APPLICATION NO.	FILING DATE	FIRST NAMED INVENTOR	ATTORNEY DOCKET NO.	CONFIRMATION NO.
10/679,392	10/07/2003	Tsutomu Tanaka	D-1494	5457
7590	08/20/2004		EXAMINER	
HAUPTMAN, KANESAKA BERNER PATENT AGENTS, LLP 1700 DIAGONAL RD, SUITE 310 ALEXANDRIA, VA 22314			SZUMNY, JONATHON A	
			ART UNIT	PAPER NUMBER
			3632

This is the second office action for application number 10/679,392, Hook Device, filed on October 7, 2003.

FIG.8A

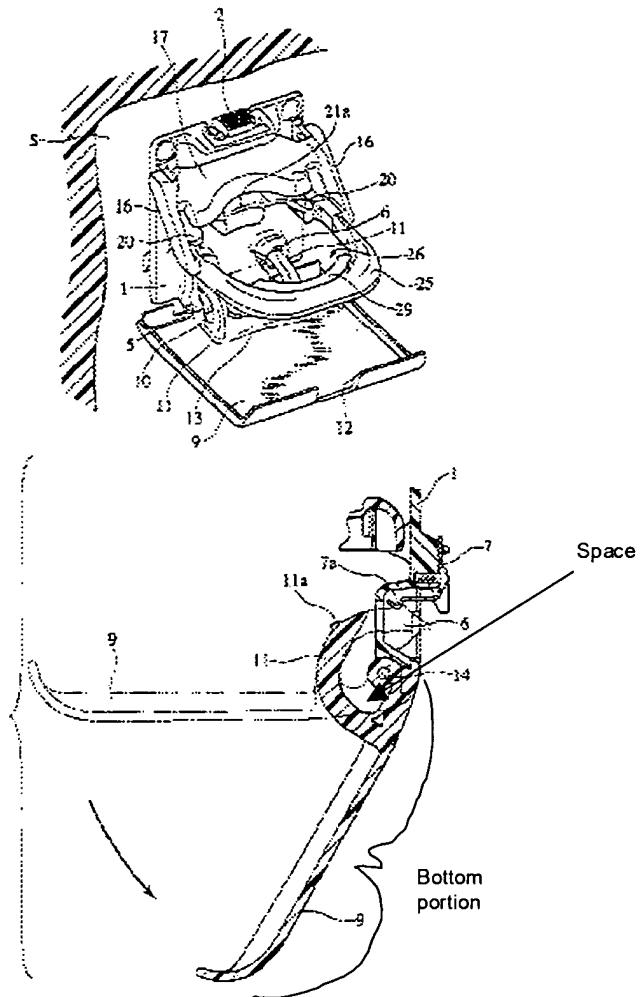
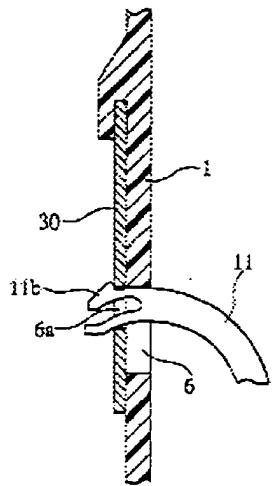
Yamada '579 discloses a hook device (above, including embodiment of figures 8A,8B) comprising a case member (1) having a stopping portion (30,6a), a hook main portion (9, generally, a "hook" is defined in Merriam Webster's Collegiate Dictionary - 10th Edition as being "a curved or bent device for... holding," so clearly, member 9 is considered a "hook main portion") disposed in the case member (members 11 go through the case, so the hook main portion is considered "in" the case member) to be rotatable between store and use positions and having an elastic member (above), and an engaging portion (above) attached to the elastic member of the hook main portion to engage the stopping portion so that the hook main portion is stopped at a use position (as in figure 3) with a predetermined open angle, wherein at least one of the stopping and engaging portion has an inclined surface (above) so that the elastic member elastically deforms in a direction that the stopping portion further engages the engaging

portion when a load is applied to the hook main portion in a direction that the hook main portion opens (this inherently happens with reference to figure 8A above), wherein the device includes urging means (15) attached to the case member (see figure 6, 14 is considered part of the case member) for urging the hook main portion in a direction that the hook main portion opens, and a latch mechanism (2,12) for holding the hook main portion at a predetermined store position (as in figure 6) against an urging force of the urging means, wherein the stopping portion is located at a rear side of the of the case member (see figure 8A,8B above) and the hook main portion has a bottom portion (above) from which the elastic member projects rearwardly and upwardly, wherein the hook main portion has a space (above) between the bottom portion and the elastic member so that the elastic member is deformable toward the bottom portion (inherently); wherein the elastic member is flexible and arranged such that when the load is applied to further open the hook main portion in the use position, the elastic member is moved toward the stopping portion to surely engage therewith (see figure 8A), wherein the engaging portion has an inwardly inclined surface relative to a radial line extending from a rotational axis of the hook main portion (with reference to figure 8B, the inclined surface is inclined inwardly relative to a radial line extending from a rotational axis of the hook main portion).

With reference to figure 8A, the engaging member and the stopping member are certainly further engaging each other, and clearly, this occurs when a load is applied to the hook main portion (figure 8A is a view of the "expanded" position, and the "expanded position" also as shown in figure 3 is meant to accommodate a load, such as a cup). Therefore, there is in fact a load in which the engagement of the engaging portion and the stopping portion prevents further opening of the main hook portion.
